Project Description: The subject site is located along Montgomery Boulevard, west of San Mateo Boulevard, within the City of Albuquerque. The proposed development consists of approximately 1.25 acres and the property is currently zoned MX-M for mixed-use, moderate intensity. The property lies within the Pressure Zone 2E in the Montgomery Trunk. The request for availability indicates plans to develop the lot for a commercial restaurant, the proposed improvements consist of a new 3,331 SF building with drive thru, hardscaped patio, and associated improvements.

Re: Project #2021-005467, SI-2022-00520, Raising Cane's Restaurants LLC Site Plan-EPC, Major Amendment (4800 Montgomery BLVD NE, Albuquerque, NM 87109)

Project #2021-005467
SI-2022-00520 Site Plan- Major Amendment

Sheet Title:
SITE KEYNOTE PLAN
Date: 03.09.2022
Project Number: 090042000
Drawn By: LW/LN
Sheet Number:

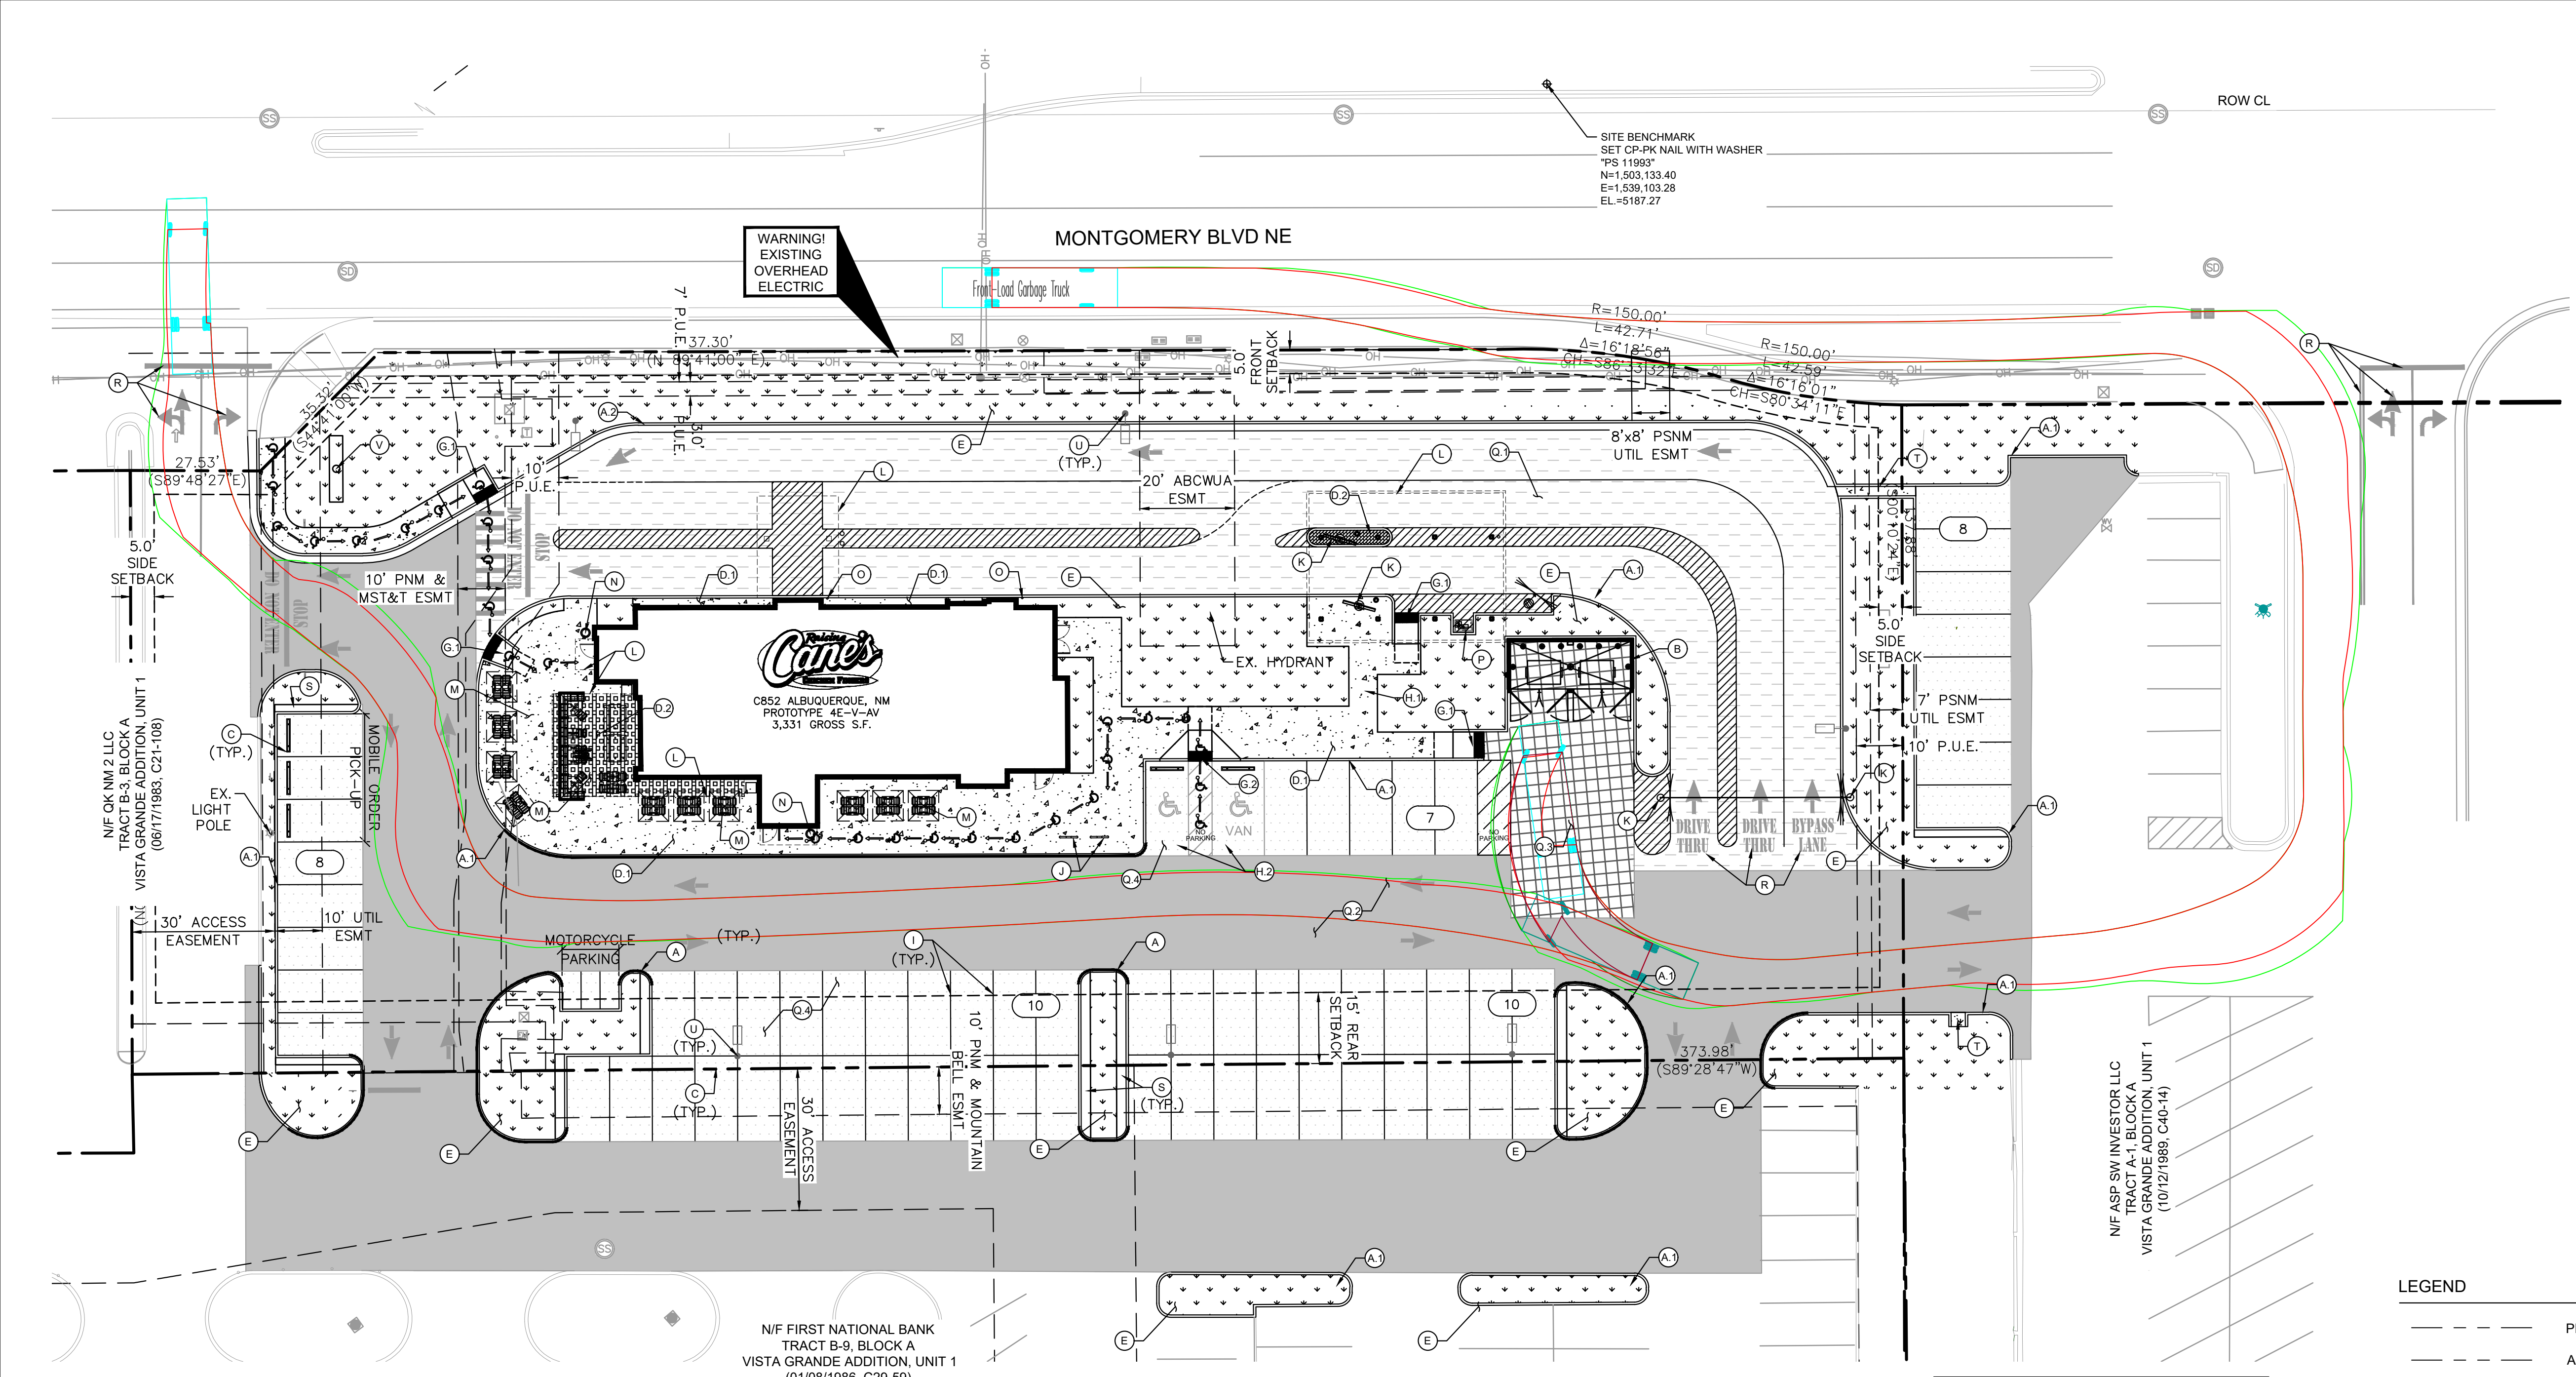
J. A 6-foot wide ADA pathway is needed to connect to the right-of-way from the business entry and from the main entry to the handicapped spaces. Show dimensioning of all new walkways.

Response: A detail of the pathway has been added to the Site Keynote Plan to confirm its width of 6'.
